REVISION COMPARISON / 5 CONTROLLED CHANGES

Synthetic teaching sample Differences independently specified, not an NX automatic report

TOP VIEW — FOOTPRINT / HOLES

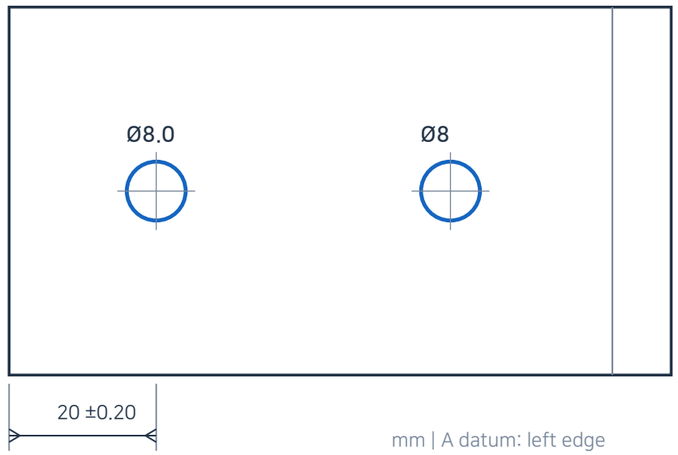
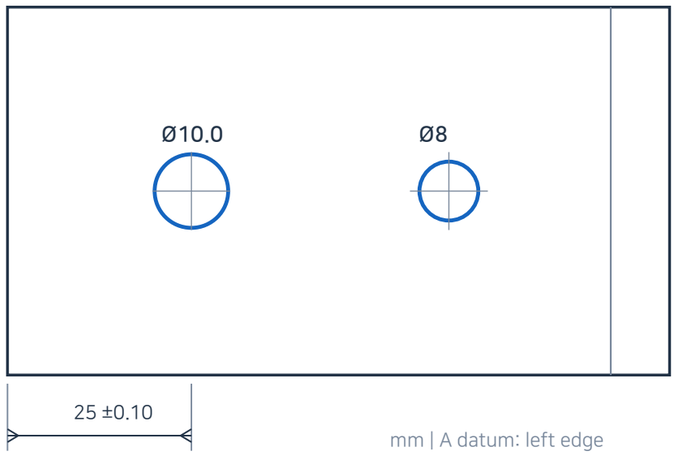
Rev A / base hole Ø8 at X20

Rev B / base hole Ø10 at X25

ID	ITEM	REV A	REV B	VERIFICATION
01	Hole X	20 mm	25 mm	3D + PDF
02	Hole Ø	8 mm	10 mm	3D + PDF
03	Position tolerance	±0.20 mm	±0.10 mm	PDF / metadata
04	Part number	BRK-042	BRK-043	PDF / PLM
05	Material	AL 6061-T6	SUS304	PDF / material attrs
